CITY OF NOVI CITY COUNCIL DECEMBER 15, 2025

SUBJECT: Consideration of the Fifth Amendment to the SDO Agreement for Cadillac of Novi, amended Preliminary Site Plan and Stormwater Management Plan.

PLAN REVIEW CENTER REPORT

Revised Preliminary Site Plan / Special Development Option Amended Concept Plan

NFE JOB NO. **0548** SHEET NO. **C3**

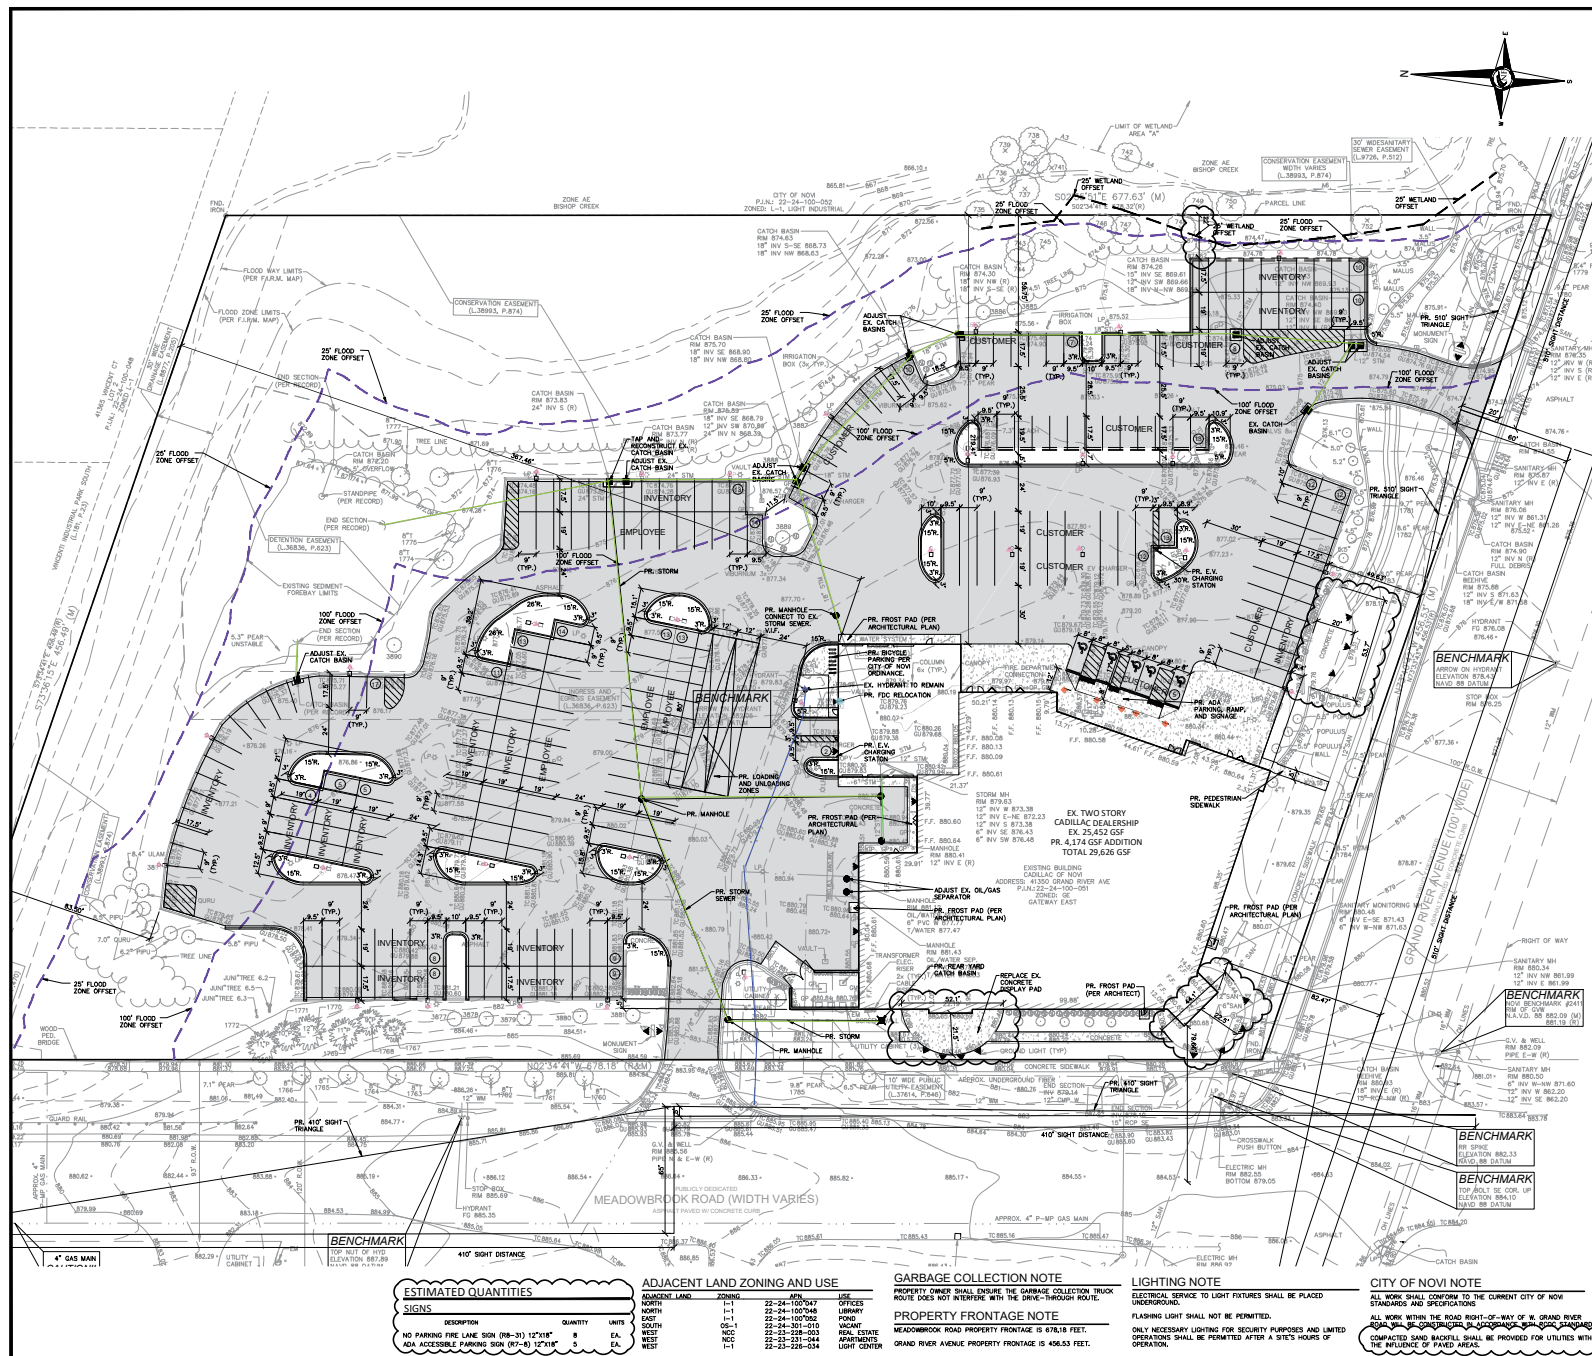
4. Indicate where the eight 'No Parking Fire Lane' signs are proposed. Show no parking signs on paving sheet C3 with other traffic control signs.
5. Provide a note that compacted sand backfill (MDOT sand Class II) shall be provided for all utilities within the influence of paved areas; illustrate and label on the profiles.

OPEN SPACE PLAN
SCALE: 1" = 60'

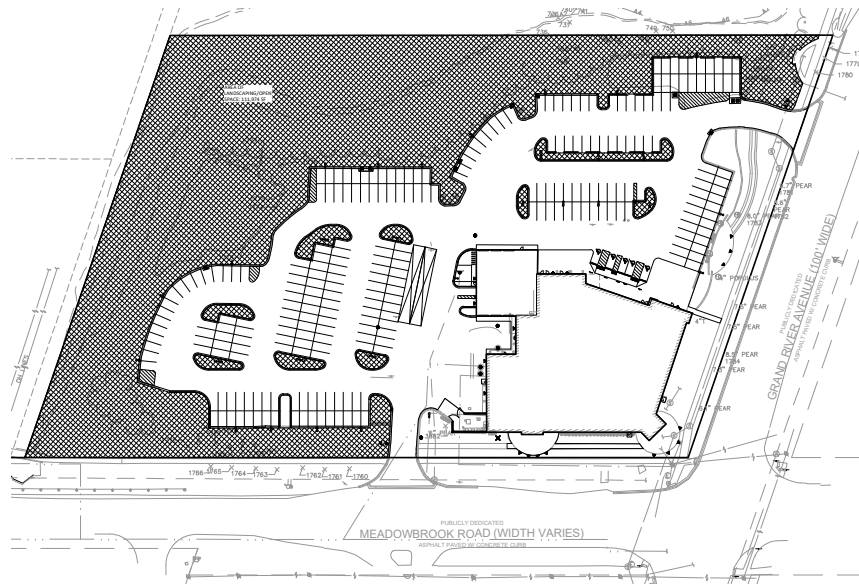
4. Open Space (Sec. 3.11.7): A minimum of 25% of the gross site area shall be left as open space. Open space areas and calculations have been provided on sheet C10, as requested, however, open spaces are still being miscalculated. **Refer to the Planning Review Chart for additional information on allowable percentages of open space categories and edit calculations to include areas along Grand River Avenue and Meadowbrook (see also example provided).**

BICYCLE PARKING DIMENSION PLAN
SCALE: 1" = 60'

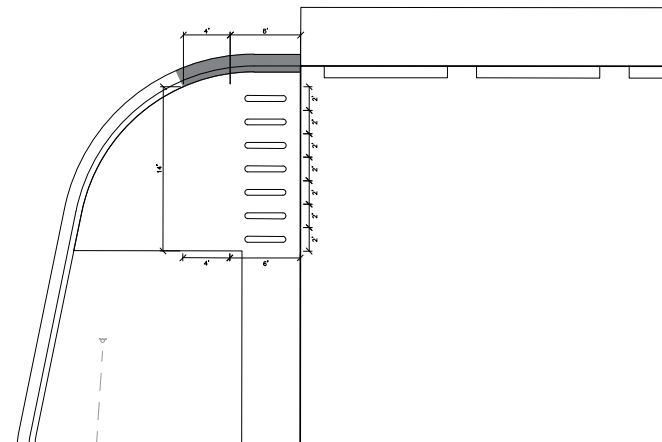
9. Bicycle Parking General Requirements (Sec. 5.6): The Preliminary Site Plan showed that all 7 bicycle parking spaces were provided in one location and the layout was not dimensioned. A dimensioned bicycle parking layout has been provided on sheet C10 as requested with the revised submittal; however the dimensions are still citing the old standards, and all spaces are still proposed in one

location. Please refer to Planning Review Chart for additional information, and see [Text Amendment 18.301](#) update to bicycle parking layout standards before Final Site Plan consideration.
